SERVICE DIRECTIVE BULLETIN NO. 0090

Revision 1

1. SUBJECT: 12 Vdc Voltage Control System Modification

2. MODELS: F-28A, 280, F-28C, and 280C Models

FIGURE 1. VOLTAGE CONTROL INSTALLATION IN SEAT STRUCTURE

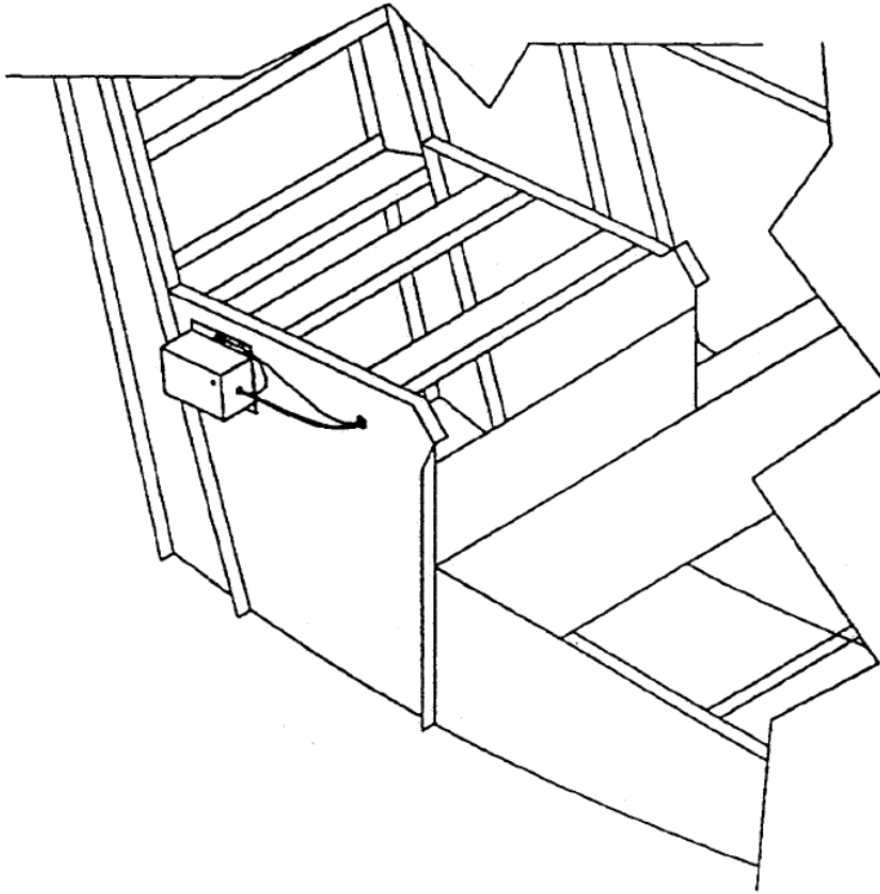
- 5.2.3.3. Install the voltage control on the outside of the seat structure as far aft as possible and with the edge of the mounting flange 1 inch/2.5 cm from the top of the seat structure (refer to Figure 1). If the voltage control interferes with the battery installation in this position, the voltage control may be installed on the inboard side of the seat structure. Clean the area around the top mounting hole in the seat structure to provide a case/terminal ground.

- NOTES:
1. Install the voltage control on the outside of the seat structure as far aft as possible with the edge of the mounting flange 1 inch/2.5 cm from the top of the seat structure. Install the voltage control on the inside of the seat structure if it interferes with the battery installation.
 2. Install an AN931-4-7 Grommet in the seat structure as required for wiring installation.
 3. Clean the area around the top mounting hole in the seat structure to bare metal for the voltage control case ground and terminal ground.
 4. Use AN520-10R8 Screws, AN340-10 Nuts, AN960-10L Washers, and AN935-10 Lock Washers to install the voltage control.

FIGURE 2. VOLTAGE CONTROL INSTALLATION

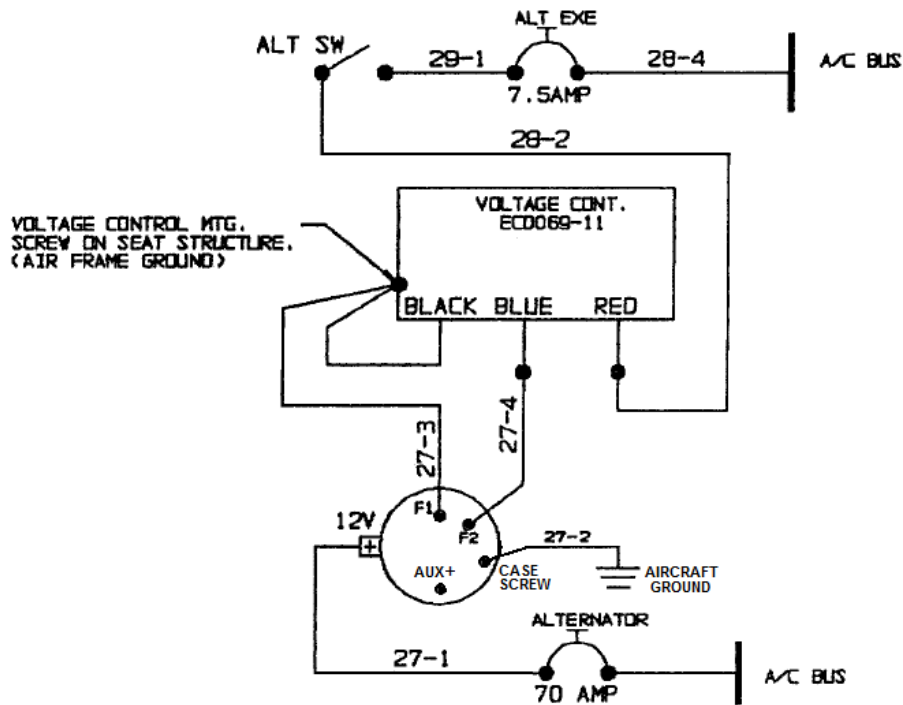
Revision 1 corrects the depiction of the alternator wiring connections and adds a step to the NOTES section to clarify the alternator ground wiring connection in Figure 2.

- 5.2.3.4. Refer to Figure 2 and install the electrical wiring for the voltage control, alternate switch, and the "ALT EXC." circuit breaker.
 - 5.2.3.5. If required, reinstall the battery.

- NOTES:
1. If the "ALT EXC." circuit breaker is already installed in the aircraft, disregard note 2 and do not modify the wiring from the bus side of the "ALT SW" to the aircraft bus.
 2. Connect wire 28-4 to the aircraft bus at one of the installed circuit breaker bus terminals.
 3. Connect the "BLACK" lead of the voltage control and wire 27-3 to the case ground/seat structure.
 4. Use 16 Gauge wire as required.
 5. F1 at alternator and the black lead of voltage control must be at the same ground potential.
 6. Connect the ground wire 27-2 to case ground. Do not connect it to the AUX+ terminal
 7. All wiring to be accomplished in accordance with AC 43B-1A.
